Subject	Change of Flat Washer 8
For Models	8406C (Diamond Core Hammer Drill)
Description	Thickness of a Flat Washer 8(one of two) has been changed from 1mm to 0.5mm.

<NEW>

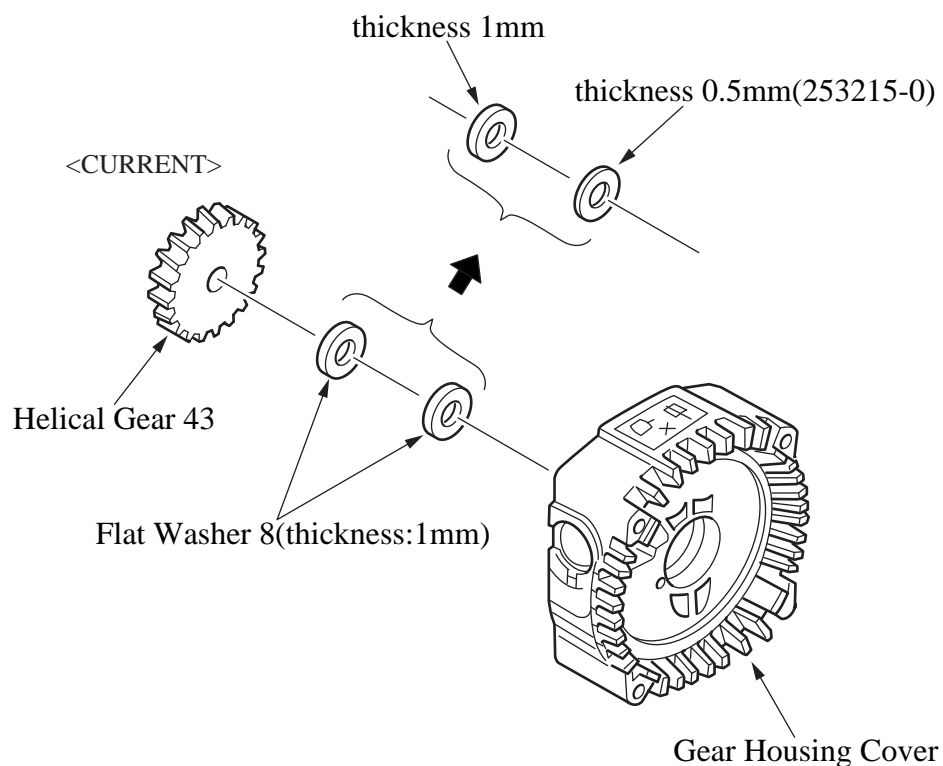
Location of new Flat Washer 8 is not designated, at either side of Helical Gear or Gear Housing Cover.

Item No.	Current part		Q'ty	I/C	New part	Q'ty		Note
021	Flat washer 8 253835-0		2		Flat washer 8 253835-0	1		Please chang these parts as a set.
084					Flat washer 8 253215-0	1
